Project No. 12091-01

Subject: Preliminary Geotechnical Evaluation and Response to City Review Comments for Proposed San Pedro Distribution Center, 1599 W. John S. Gibson Boulevard, Los Angeles, California

5.0 RESPONSE TO CITY REVIEW COMMENTS

Response to Comment No. 14

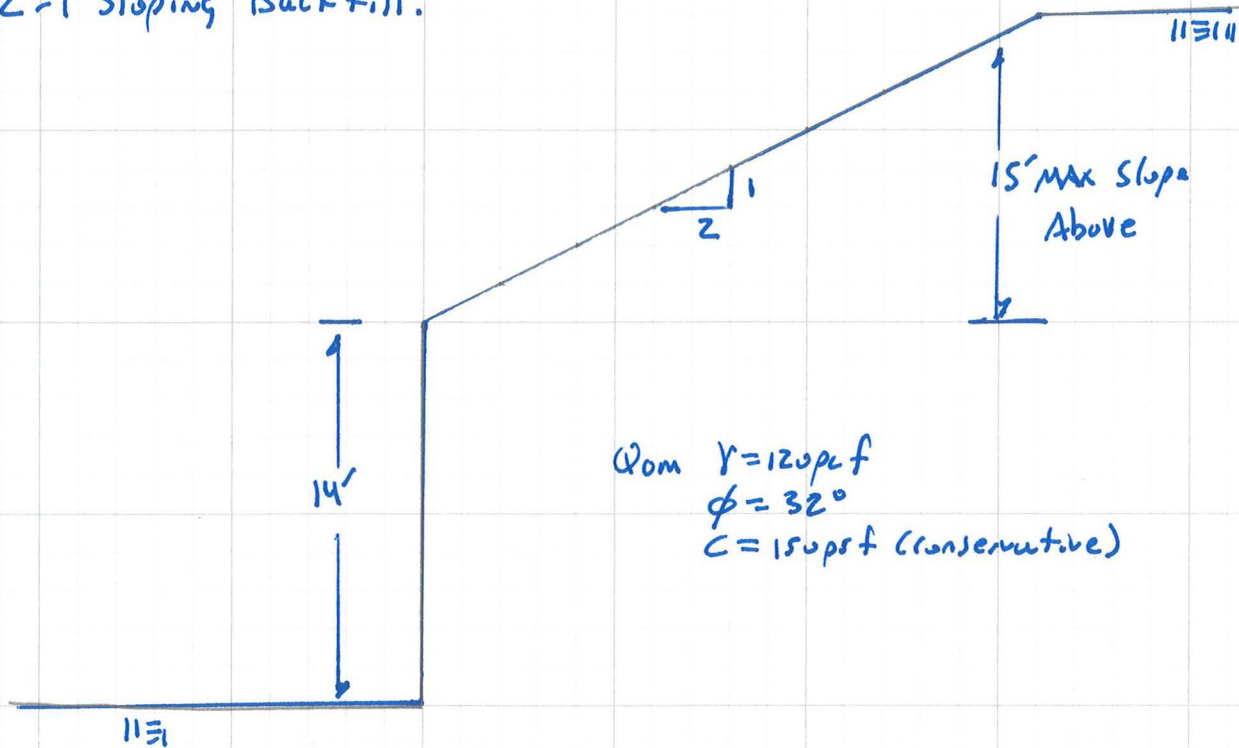
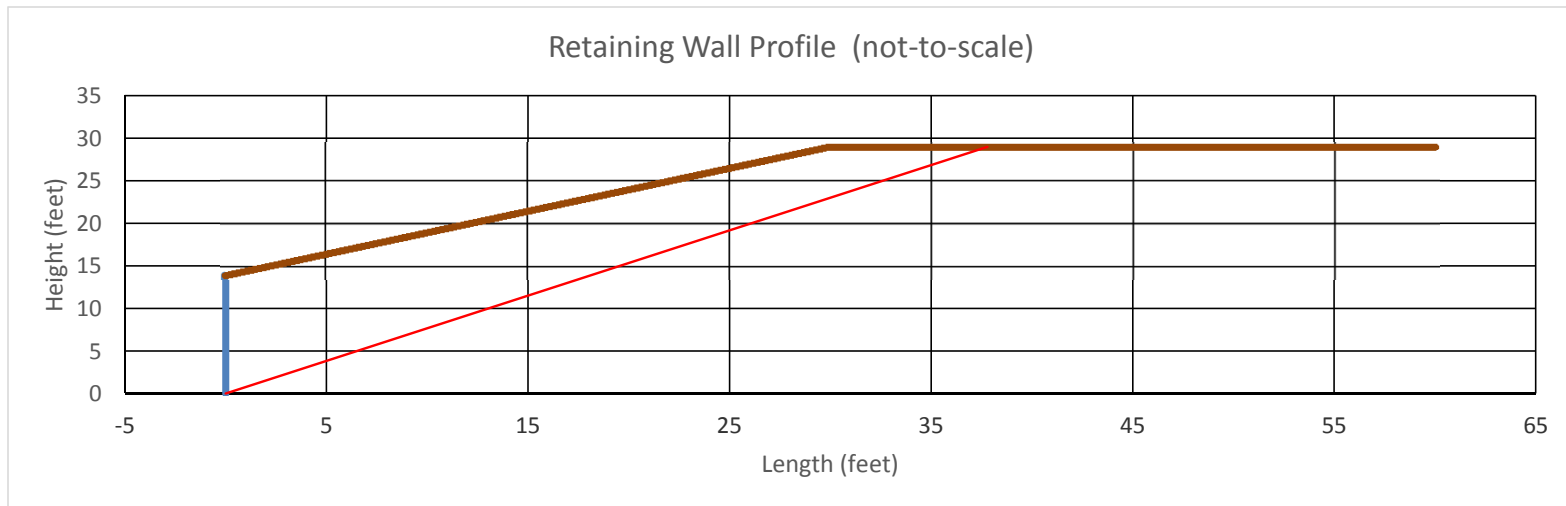
“Provide retaining wall/basement design calculations and recommendations for lateral earth pressure due to earthquake motions for walls higher than 6 feet, as required by Section 1803.5.12 of the 2017 Los Angeles Building Code.”

SEISMIC LATERAL EARTH PRESSURES

SHEET
1 of 5

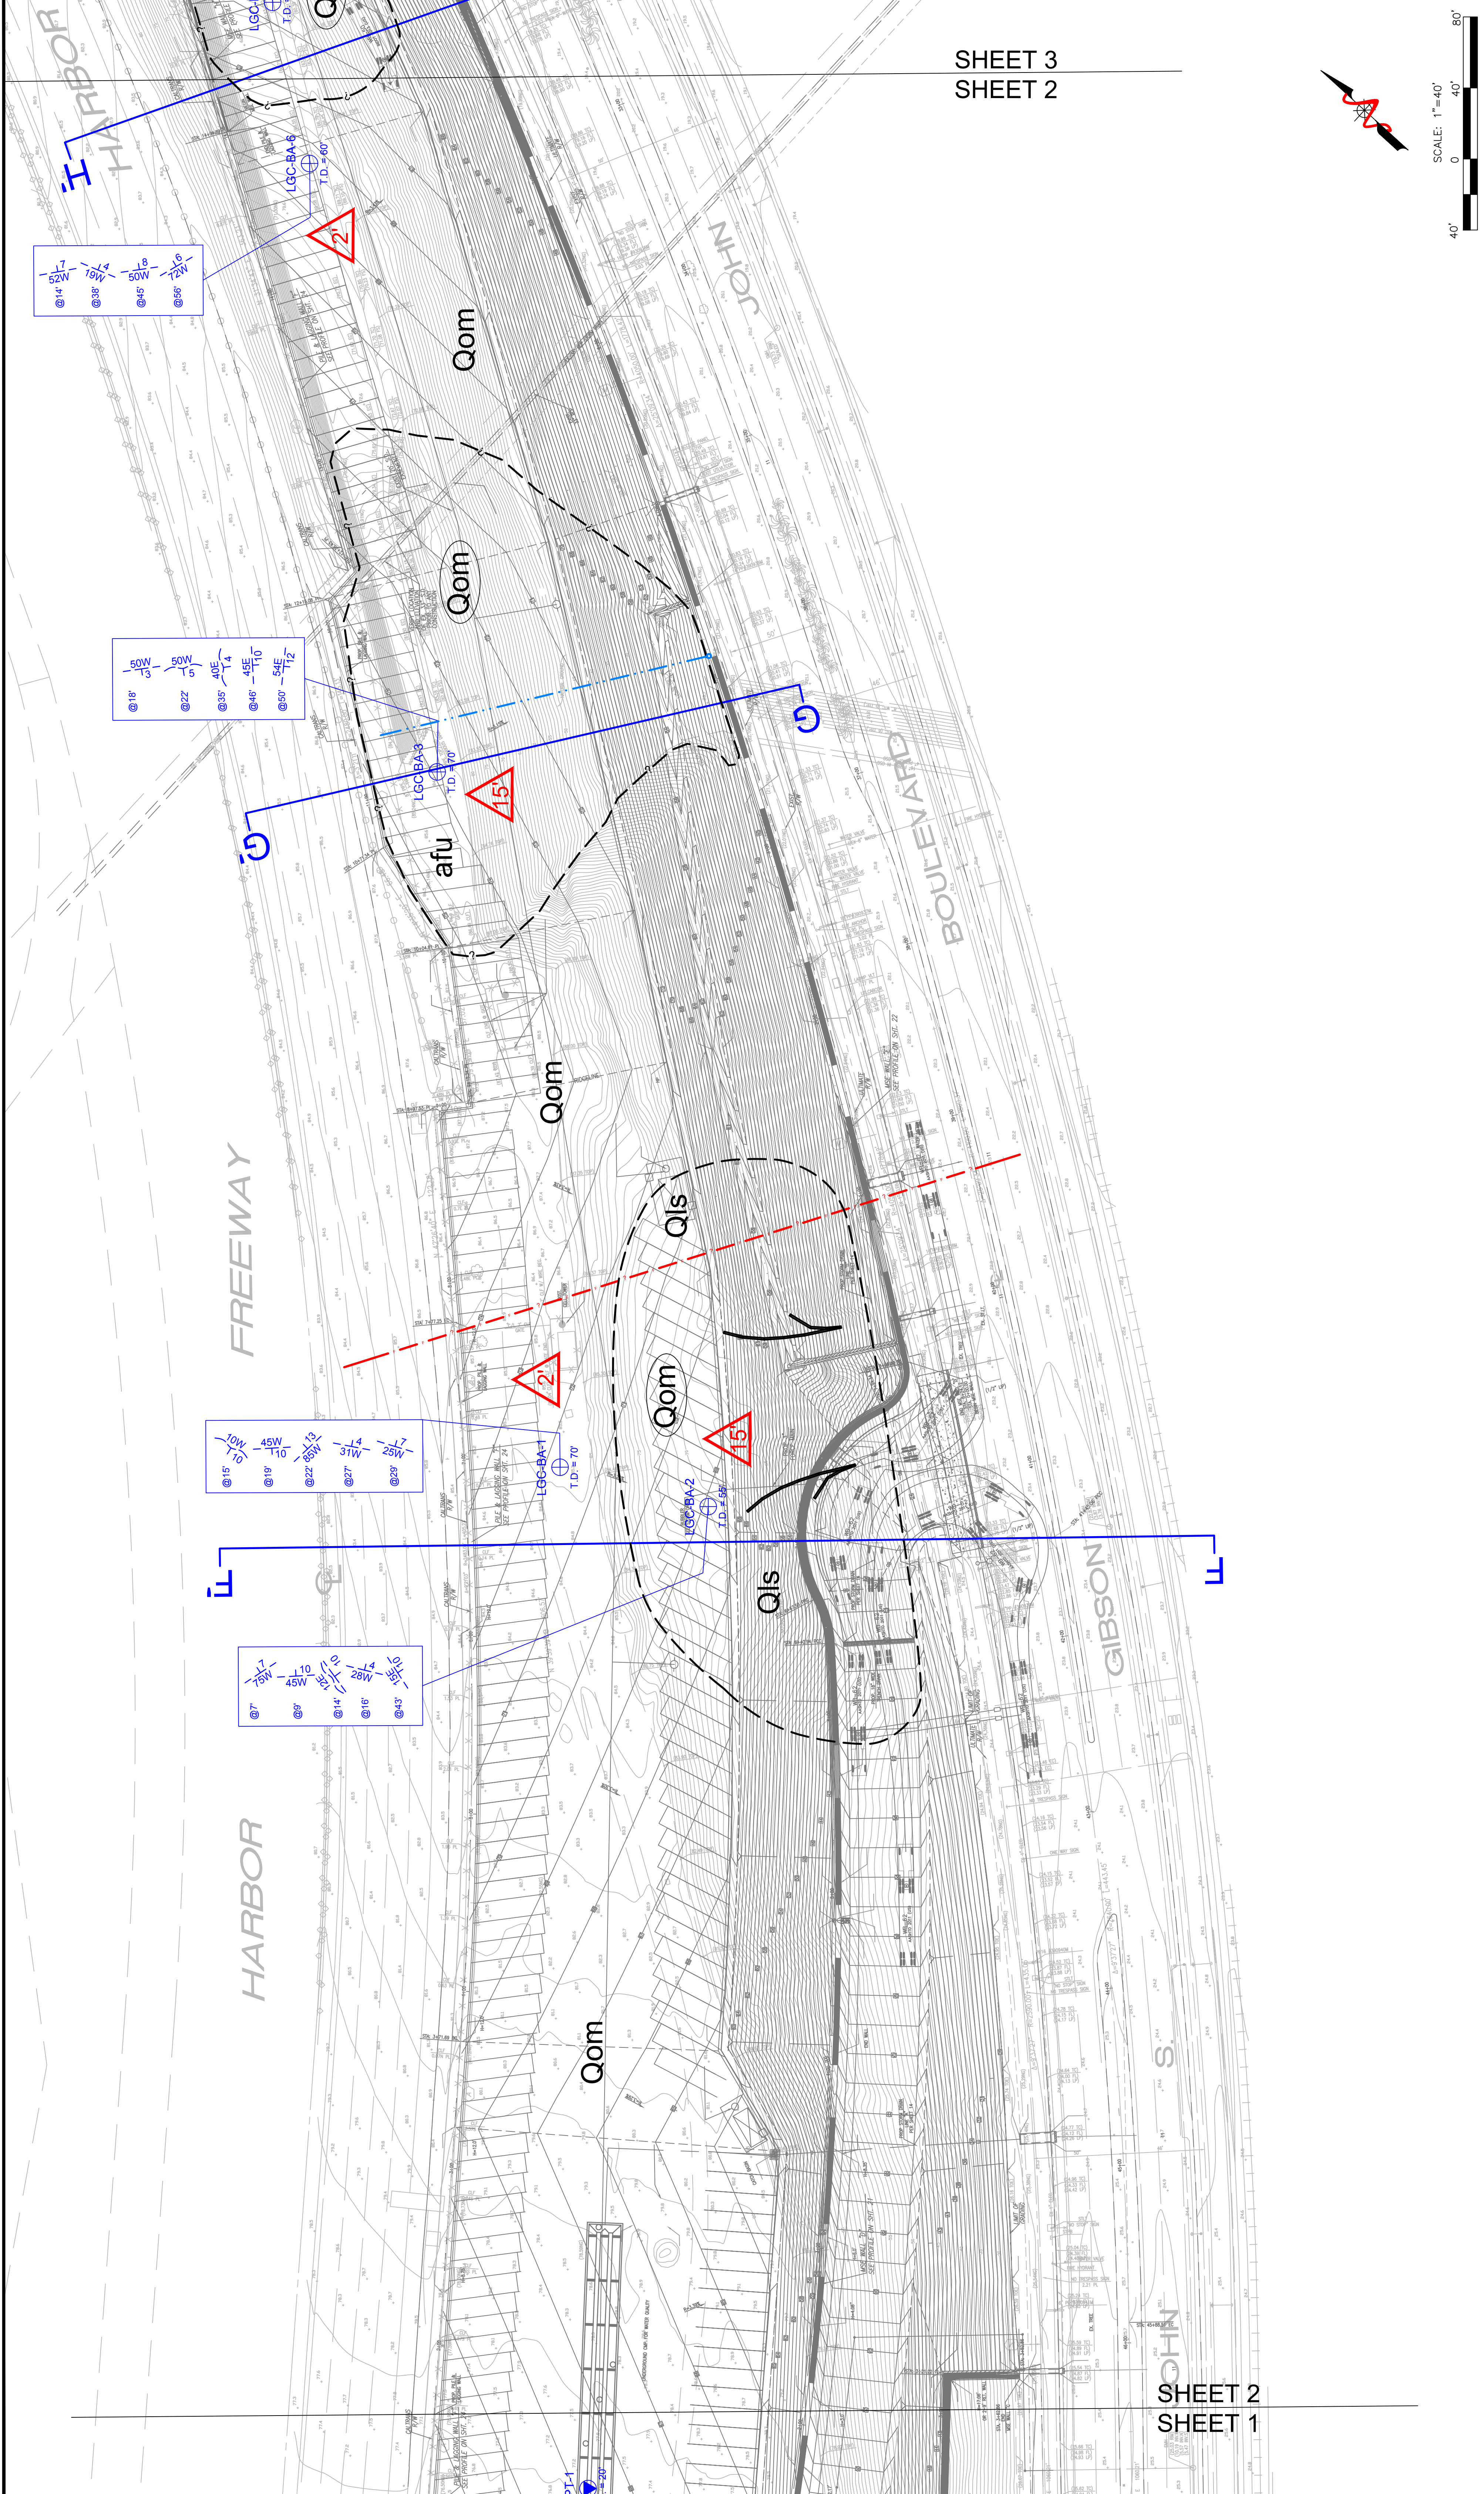
“No map was provided with the current update report reflecting the proposed site conditions. Provide recommendations and revise the plan(s) and cross sections(s) for providing the required building setback from the toe of the ascending slope as specified by Code Section 1808.7.1.”

“Provide a geologic map and cross sections that are based upon conceptual grading or site development plans, to illustrate all proposed and existing contours relative to the planned grading and/or construction, along with all off-site slopes and conditions that could adversely affect the stability or safety of the site (7006.3.2). The geologic map and cross sections shall depict the top and bottom of slopes; lithologic contacts; bedding attitudes; locations of slumps, landslides, or faults relative to the subject site; existing and proposed topographic profiles; existing and proposed structures; and, required Code setbacks. (7006.3.2)”

Refer to the attached Geotechnical Map (Sheets 1 through 3). No building structures are planned for the site.

Refer to the attached Geotechnical Map and Geotechnical Cross Sections (Sheets 1 through 5). No building structures are planned for the site.
